H11862

OPR-G347-NRT2-08

**HYDROGRAPHIC SURVEY
H11862**

B. DATA ACQUISITION AND PROCESSING *See also the Evaluation Report*

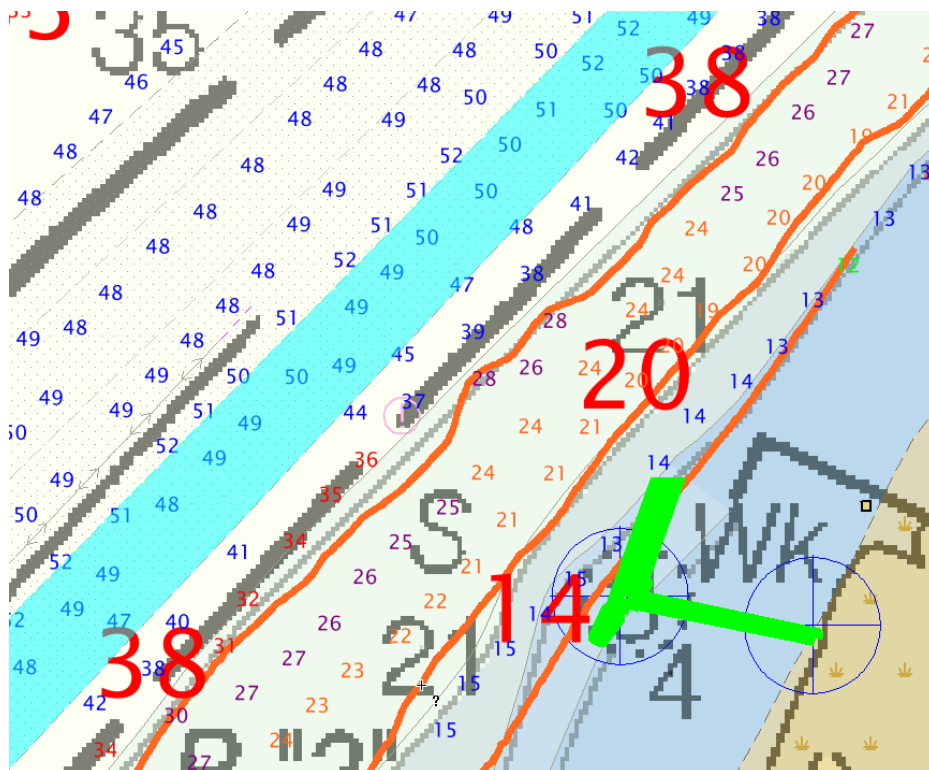
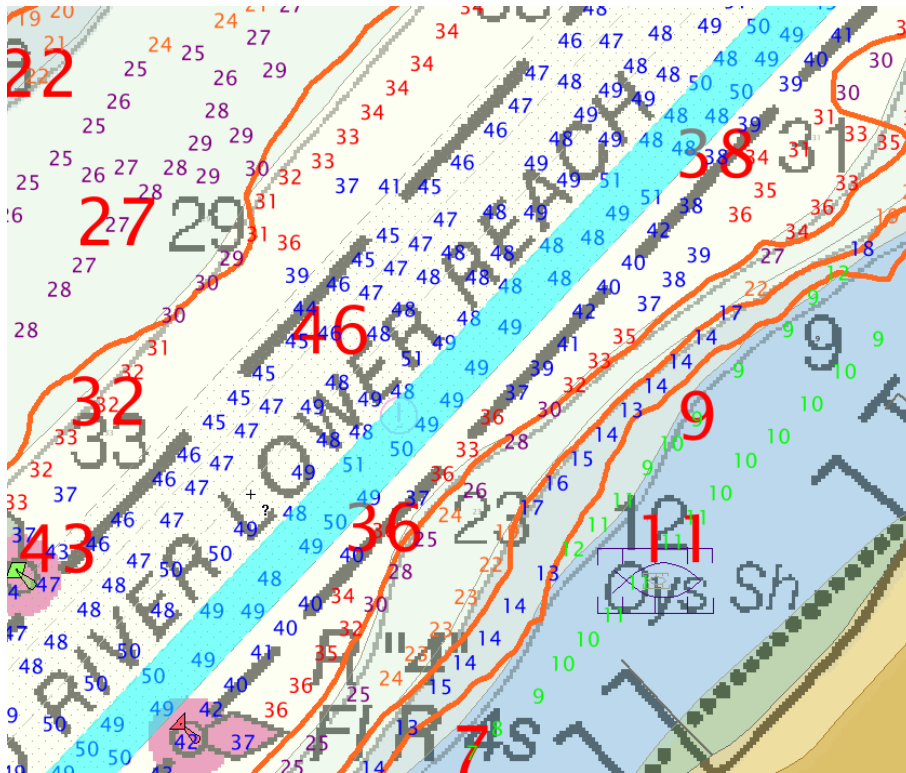
b. There are several conflicts between the tabulated controlling depth of 47.2 feet for the Wando River Lower Reach channel left inside quarter and present survey depths. There is a 47.1 foot present survey depth in Latitude 32°49’07.630”N, Longitude 079°54’24.614”W. In the vicinity of Latitude 32°49’16.151”N, Longitude 079°54’15.088”W there are several conflicts with depths ranging from 46.7 feet to 47.0 feet. (See Below)

c. There are several conflicts between the tabulated controlling depth of 41.0 feet for the Wando River Lower Reach channel right outside quarter and present survey depths. There is a 38.5 foot present survey depth in Latitude $32^{\circ}48'46.398''N$, Longitude $079^{\circ}54'34.005''W$ conflict based on raster chart limits. There is a 38.5 foot present survey depth in Latitude $32^{\circ}49'02.438''N$, Longitude $079^{\circ}54'25.062''W$ conflict based on raster chart limits. (See Below first figure) Centered in the vicinity of Latitude $32^{\circ}49'16.426''N$, Longitude $079^{\circ}54'09.316''W$ there are several conflicts with depths ranging from 36.2 feet to 40.5 feet because of the raster chart limits. (See Below second figure)

Bridge as depicted on raster chart and ENC:

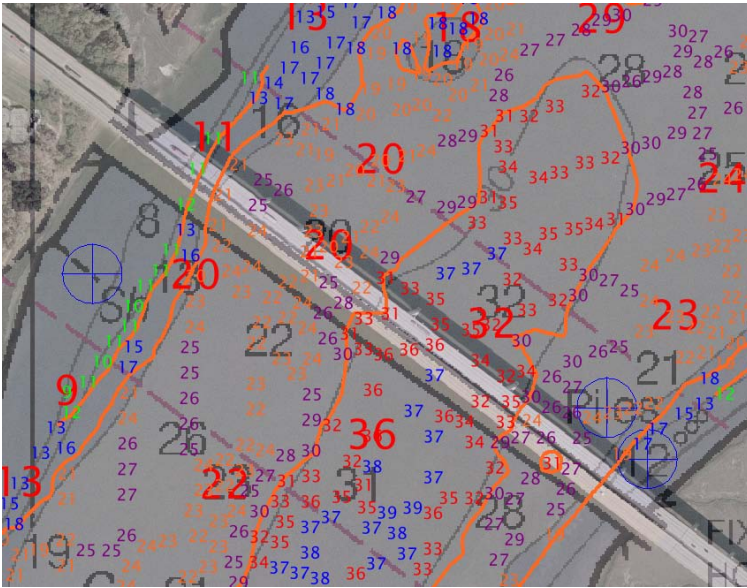
The bridge charted in the vicinity of Latitude 32°51'35.209"N, Longitude 079°53'47.019"W is depicted correctly according to the ENC and raster chart for this area, but when the orthoimagery for the area is compared, there are some major conflicts. The south western edge of the bridge in the orthoimagery plots on the north western edge of the bridge on the raster chart and ENC. The ENC is about 20 meters north of the charted image. Near the south eastern edge of the charted bridge, the orthoimagery is only about 6 meters north. The bridge needs to be repositioned north east. (See Below) Final disposition of this item will be left up to RSD.
